Kirwin NWR
Replacement of Multiple Boat Ramps

Kirwin
National Wildlife Refuge

DESIGNED: KA	DRAWN: KA	CHECKED:	MAW
DATE: 08/06/2022	DRAWING NO. 6R-KS-461-100		SHEET 1 OF 4

Kirwin NWR SOUTH SHORE Replacement of Multiple Boat Ramps					SUB-SHEET
DESIGNED KA	DRAWN KA	CHECKED MAW	DATE 05/01/2026	DRAWING NO. 6R-KS-461-100	SHEET 3 OF 4

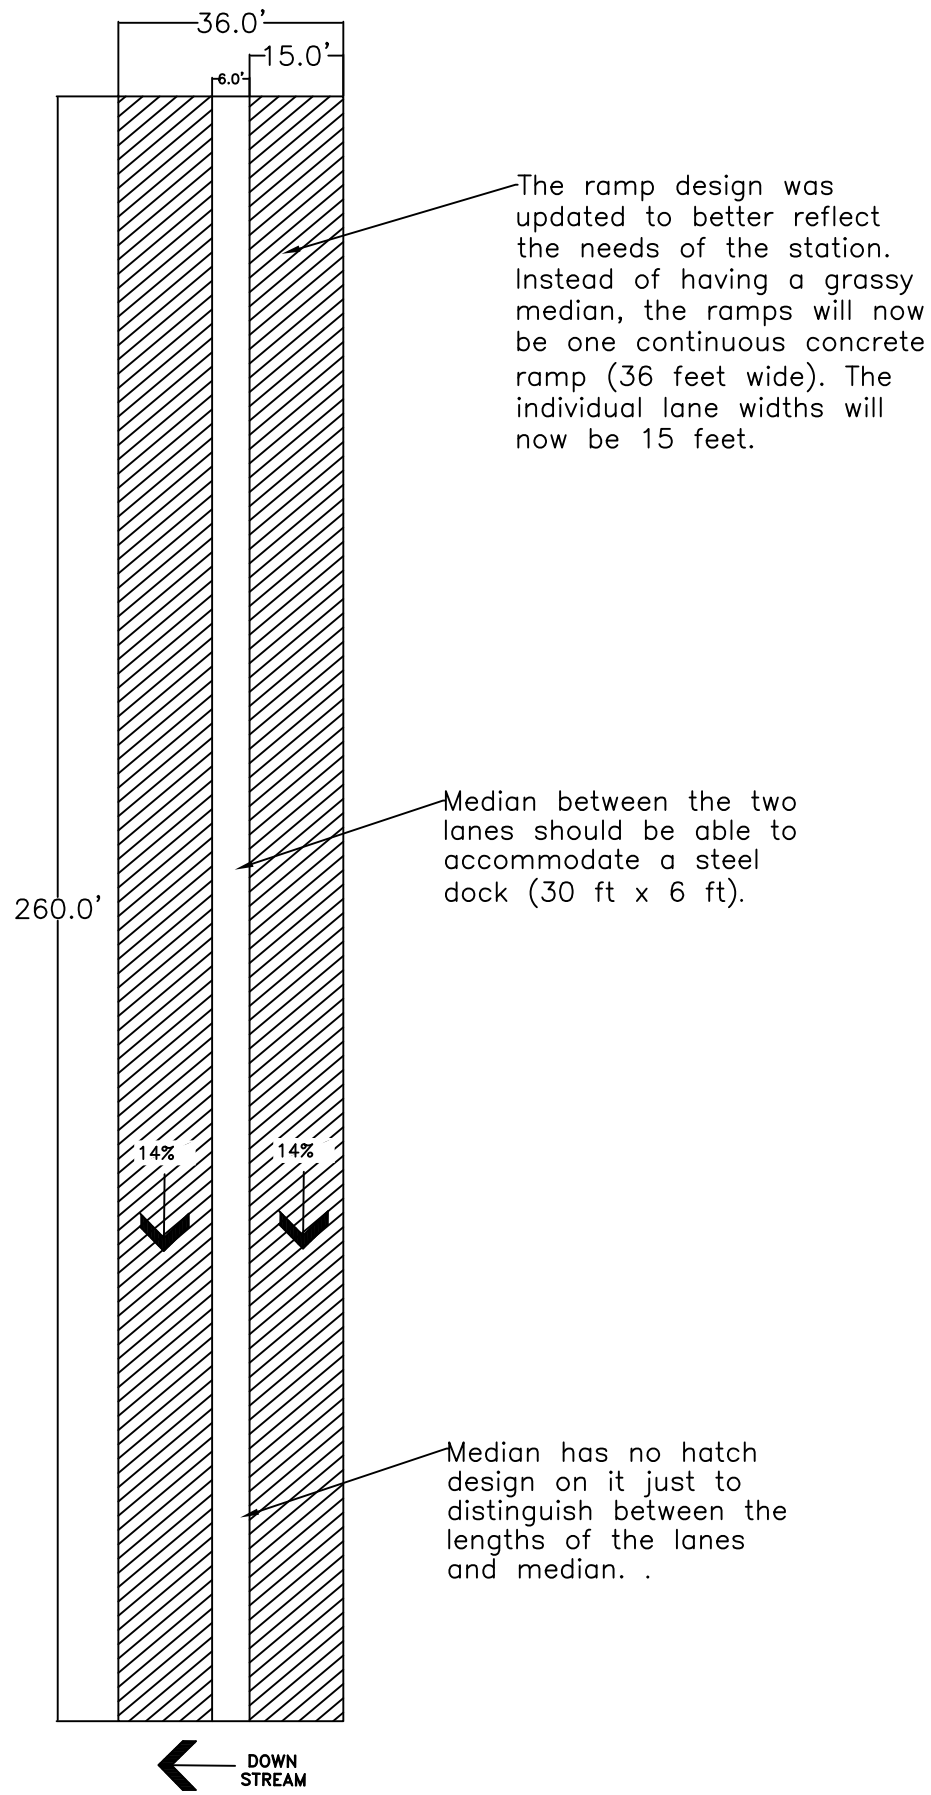
The ramp design was updated to better reflect the needs of the station. Instead of having a grassy median, the ramps will now be one continuous concrete ramp (36 feet wide). The individual lane widths will now be 15 feet.

Median between the two lanes should be able to accommodate a steel dock (30 ft x 6 ft).

Median has no hatch design on it just to distinguish between the lengths of the lanes and median. .
